DEPARTMENT OF TRANSPORTATION

DIVISION OF AERONAUTICS – M.S. #40

April 1, 2015

The California Department of Transportation (Caltrans), Division of Aeronautics, conducted a State permit compliance inspection and Federal Aviation Administration (FAA) Airport Master Record (Form 5010-1) update of the Little River Airport, FAA Site No. 01778.*A, on March 19, 2015. We appreciate the cooperation Mr. Bob Morgan, Mr. Dave Thorpe, and you provided to us during our inspection. The updated information will be entered into State and FAA Airport Master Records.

Photo 1 - Trees penetrate the Runway 11, FAR Part 77, 20:1 Approach Surface.

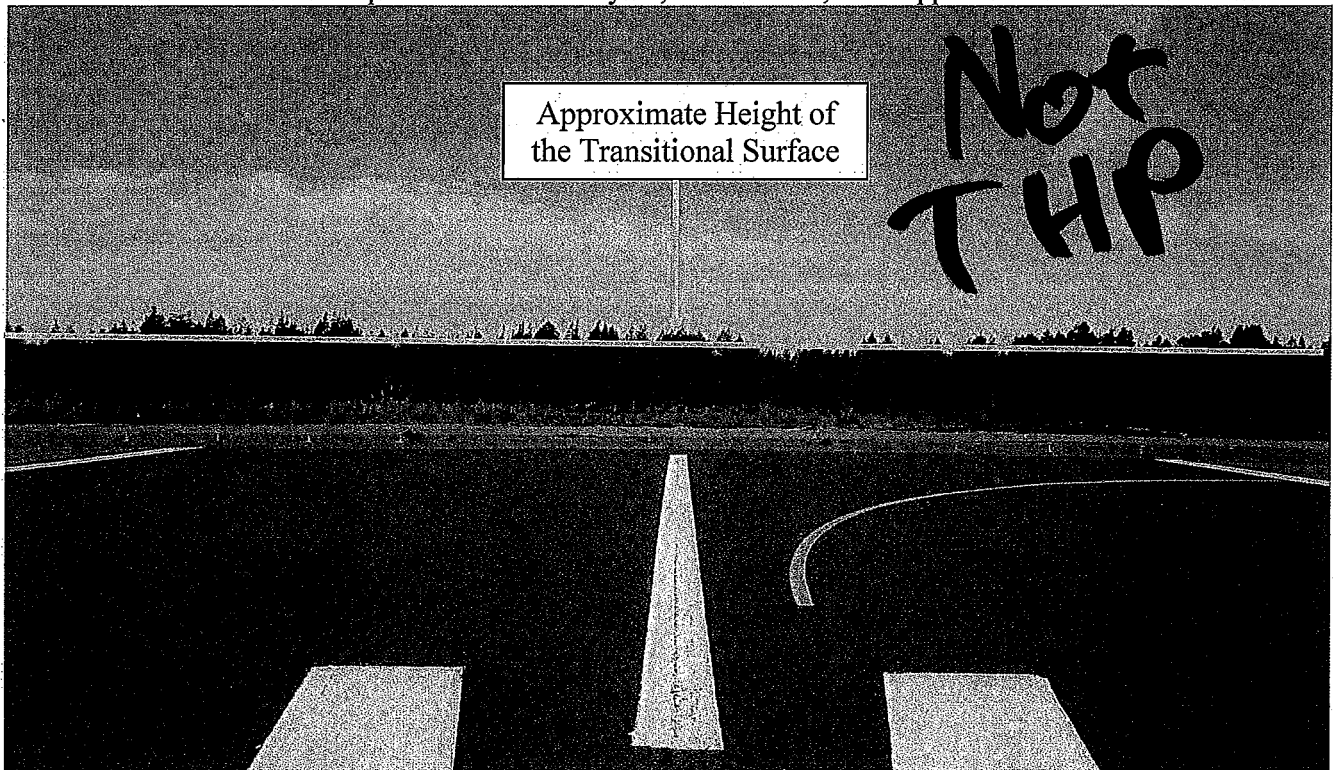
1. A line of trees 1,250 feet west of the Runway 11 displaced threshold penetrate the Federal Aviation Regulation (FAR) Part 77, 20:1 Approach Surface by approximately ten feet (please refer to Photo 1). Several other trees under the approach must be monitored and trimmed or removed, if they penetrate the Approach Surface.

Photo 2 - Trees penetrate the FAR Part 77, 20:1 Transitional Surface.

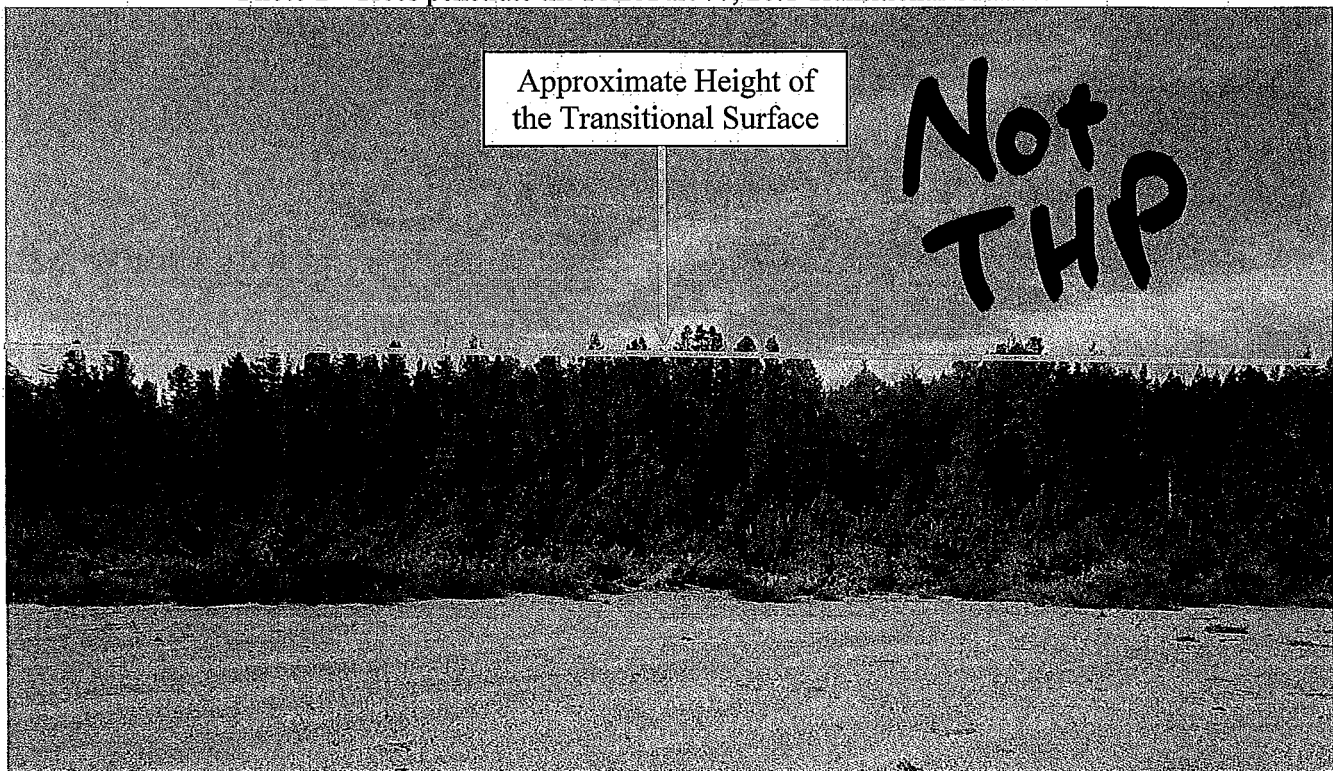
- a. Trees located approximately 250 feet southeast of the Runway 11 displaced threshold and 750 feet southwest of the runway centerline penetrate the FAR Part 77, 7:1 Transitional Surface by approximately five feet (please refer to Photo 2).

With the exception of items a and d, Caltrans recognizes that this condition has existed and increased over a period of time. Caltrans requests a definitive plan within 90 days of receipt of this letter to address and maintain obstruction-free FAR Part 77 imaginary surfaces to the airport to continue to allow operations at night. Failure to comply may lead to initiation of action to suspend night operations.

Photo 3 - Trees penetrate the FAR Part 77, 20:1 Transitional Surface.

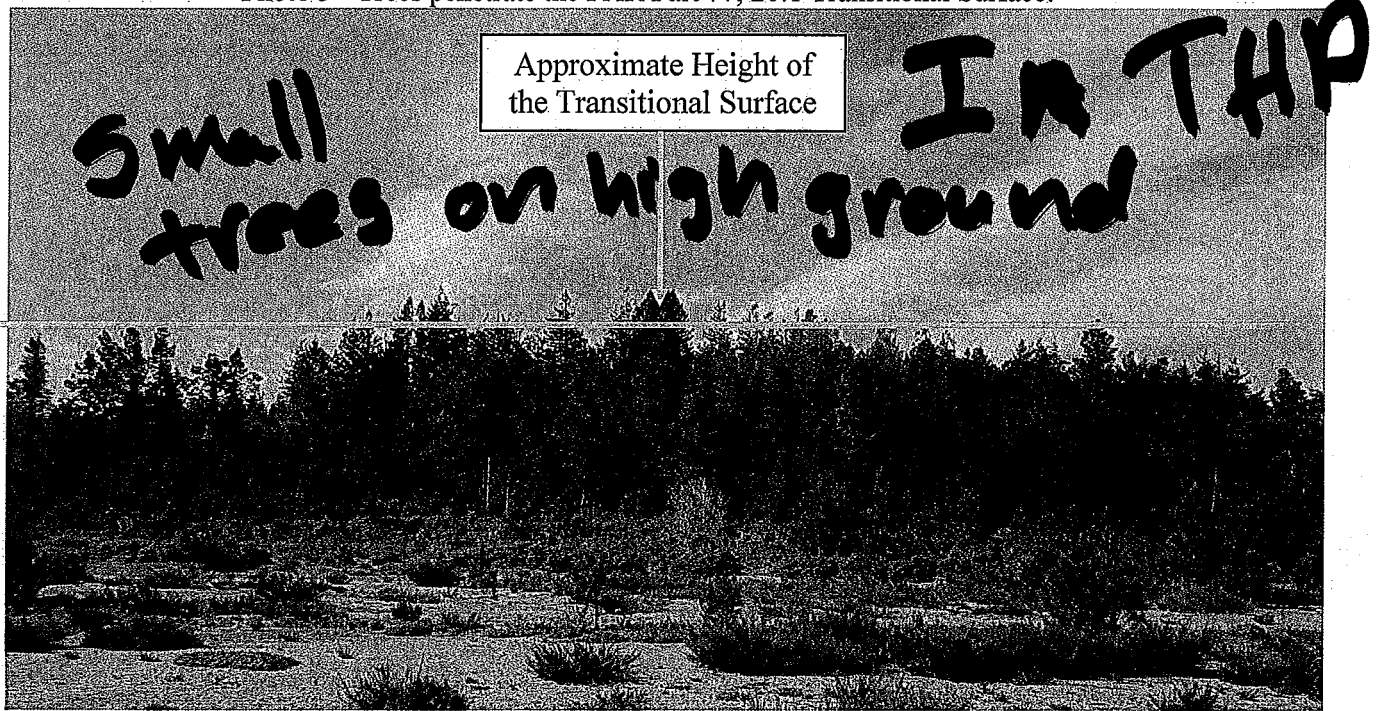
- b. Trees located approximately 1,000 feet southeast of the Runway 11 displaced threshold and 700 feet southwest of the runway centerline penetrate the FAR Part 77, 7:1 Transitional Surface by approximately ten feet (please refer to Photo 3). This is a repeat discrepancy.

Photo 4 - Trees penetrate the FAR Part 77, 20:1 Transitional Surface.

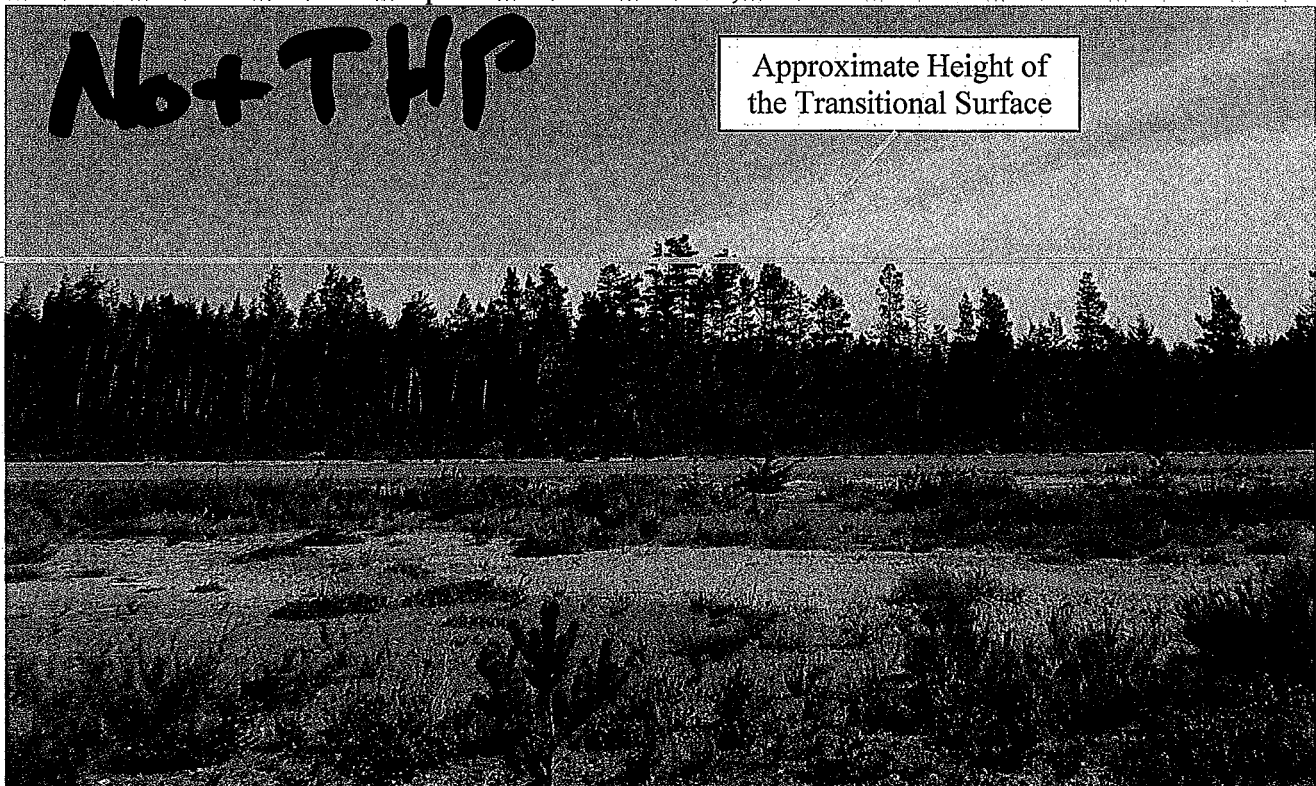
- c. Trees located approximately 750 feet southeast of the Runway 11 displaced threshold and 700 feet northeast of the runway centerline penetrate the FAR Part 77, 7:1 Transitional Surface by approximately five feet (please refer to Photo 4). This is a repeat discrepancy.

Photo 5 - Trees penetrate the FAR Part 77, 20:1 Transitional Surface.

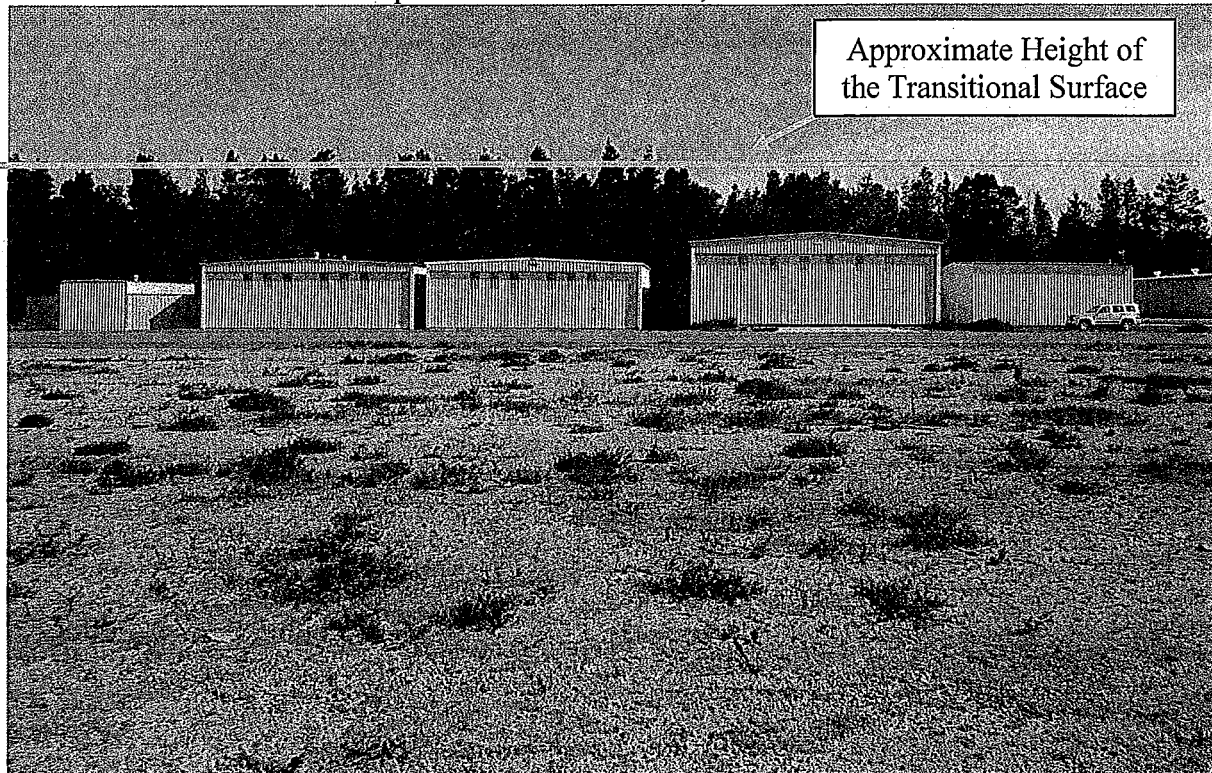
- d. Trees located just north of the hangars at midfield penetrate the FAR Part 77, 7:1 Transitional Surface by approximately three feet (please refer to Photo 5).

Photo 6 - Trees penetrate the FAR Part 77, 20:1 Transitional Surface.

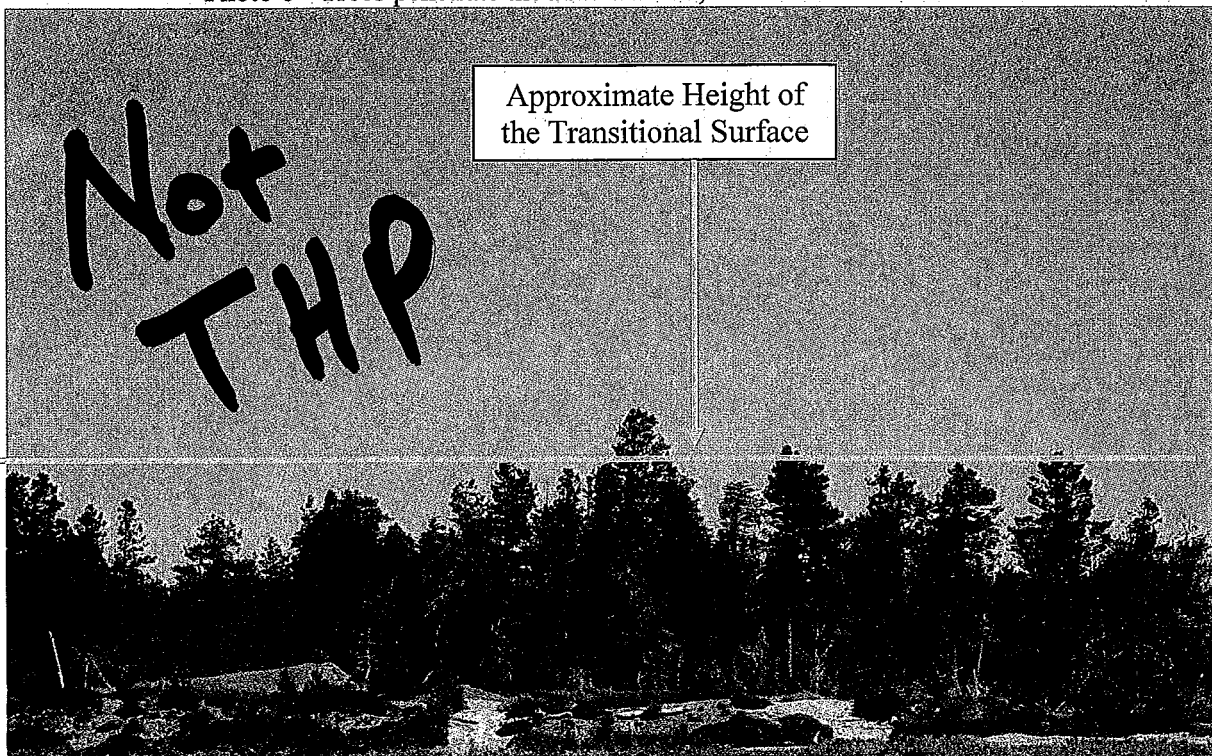
- e. Trees abeam of the Runway 29 threshold and 750 feet northeast of the runway centerline penetrate the FAR Part 77, 7:1 Transitional Surface by approximately five feet (please refer to Photo 6). This is a repeat discrepancy.
